Amendments to the Drawings

REMARKS

Amendment dated February 2, 2005
Reply to Office Action of November 3, 2004
Annotated Sheet Showing Changes

FIG.1

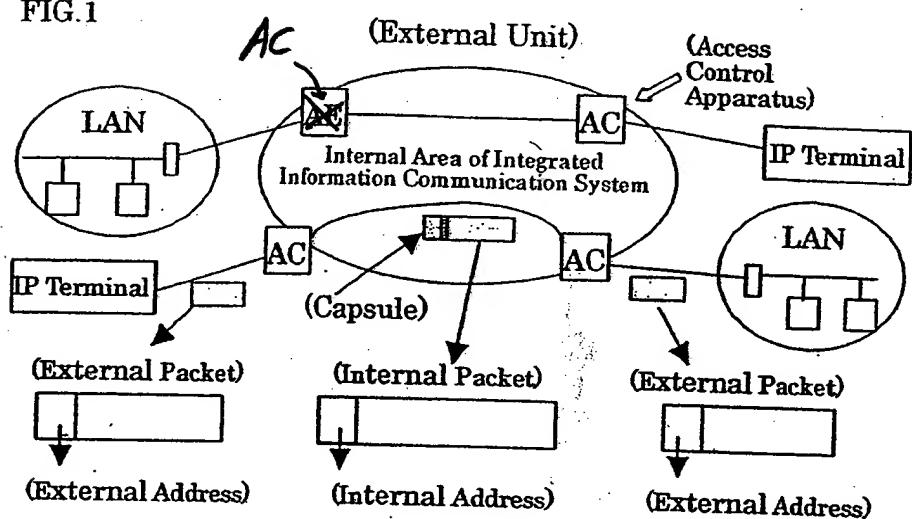
The attached sheets of drawings include proposed changes to Figs. 1 and 25 and replace the original sheets including Figs. 1 and 25. In Fig. 1, reference AE in the upper left box has been replaced by reference AC, as per the suggestion of the Examiner. In Fig. 25, table 2412-1, column titles “Internal Source Address” and “Internal Destination Address” have been interchanged and column titles “External Source Address” and “External Destination Address” have been interchanged.

The Applicants propose amending Figs. 1 and 25 as shown on the sheets submitted herewith.
